# TOWN OF PLAINFIELD DESIGN REVIEW COMMITTEE

**CASE NO.:** DP-25-103

**Project Page:** [Wawa Main Street \(Walgreens\)](#)

Development Plan approval for a 6,372 square foot (+/-) gas station/convenience store on 2.63 acres (+/-) subject to approval of the Zone Map Amendment

### Camby Road Screening Example

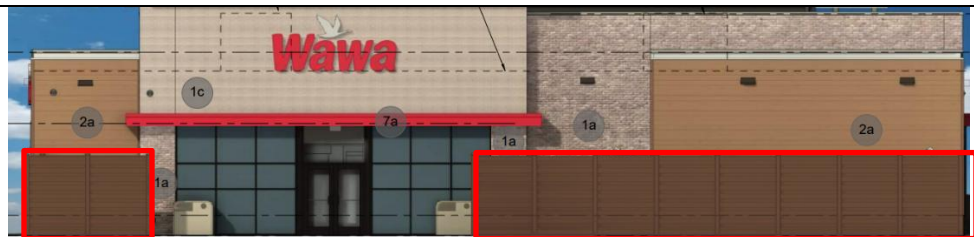
The applicant has elected to display their propane tanks & ice coolers outdoors and facing towards the intersection of Main Street & Dan Jones Road. These items must be screened from the public right-of-way, and the applicant has elected to use a fence running most of the length of the east elevation of the building. This is contrary to how the Camby Road Wawa location screening, which created alcoves using the footprint of the building to more discretely tuck away the display items without the need for as much fencing.

This example shows how Plainfield's first Wawa location chose to screen its outdoor display items. The red boxes indicate where the outdoor display items are located behind the screening. The screening is flush with the building in this case.
